Access Compliance Report

Public Rights-of-Way

(Curb Ramps)

Intersection ID: 26038	Main Street: ELM_LN	Cross Street: PINEVILLE-MATTHEWS_RD	Location: SW
ADA ID: 1AA173BE49F7	Ramp Type: PerpDiag	Initial Pass/Fail: Fail	Overall Compliance: No
Codes/Mitigation Info/Possible Solution		Field Measurements/Component Compliance	
		Severity Score: 42.5

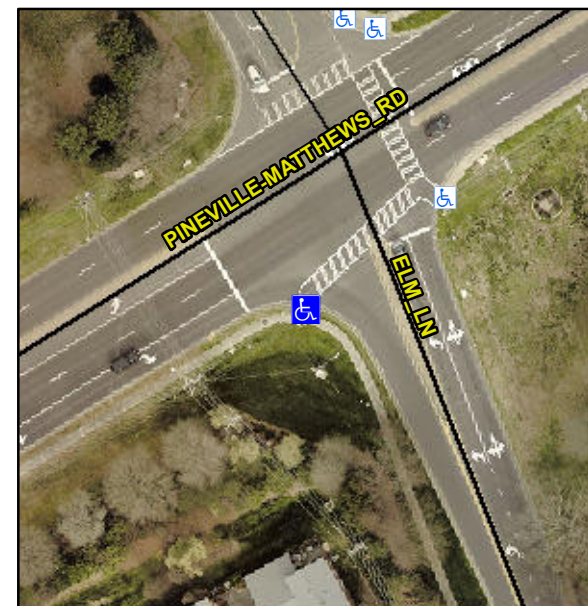
Remove & Replace Curb Ramp With Two New Directional Ramps or Equivalent.

R304.5.1, R304.2.2, R304.5.3

Compliance	Description	Data	Compliance	Description	Data
N/A	Ramp Length (in)	107.0	No	Ramp Slope (%)	8.4
No	Ramp Width (in)	35.0	No	Ramp XSlope (%)	5.3
N/A	Flare Type LT	N/A	N/A	Flare Type RT	N/A
N/A	Flare Slope LT (%)	N/A	N/A	Flare Slope RT (%)	N/A
N/A	Flare Traversable LT?	N/A	N/A	Flare Traversable RT?	N/A
N/A	Landing Length (in)	N/A	N/A	DWS Provided?	N/A
N/A	Landing Width (in)	N/A	N/A	DWS Contrast?	N/A
N/A	Landing Slope (%)	N/A	N/A	DWS Length (in)	N/A
N/A	Landing X Slope (%)	N/A	N/A	DWS Full Width?	N/A
N/A	Landing Curb? (Y/N)	N/A	N/A	DWS Offset (in)	N/A
N/A	Shared Landing?	N/A			
N/A	Gutter Ponding?	N/A	N/A	Gutter Slope (%)	N/A
N/A	Gutter Lip Ht (in)	N/A	N/A	Gutter X Slope (%)	N/A
N/A	Painted X Walk1?	Yes	N/A	Painted X Walk2?	No
	X Walk 1 Direction	To NE		X Walk 2 Direction	To NW
N/A	X Walk 1 Width (in)	108.0	N/A	X Walk 2 Width (in)	N/A
	X Walk 1 Slope (%)	5.0		X Walk 2 Slope (%)	5.0
	X Walk 1 X Slope (%)	4.2		X Walk 2 X Slope (%)	0.3

N/A	Ramp inside XWalk1?	Yes	N/A	Ramp inside XWalk2?	N/A
	Road Slope (%)	4.4	N/A	Clear Space?	N/A
	Road X Slope (%)	6.5	N/A	Clear Space to XWalk (in)	N/A
N/A	Any Obstructions?	N/A	N/A	Storm Grate/Utility Hazard?	N/A
	Obstruction Type			Storm Grate/Utility Type	
		N/A			N/A
		Yes		Surface Condition? (G/P)	Good
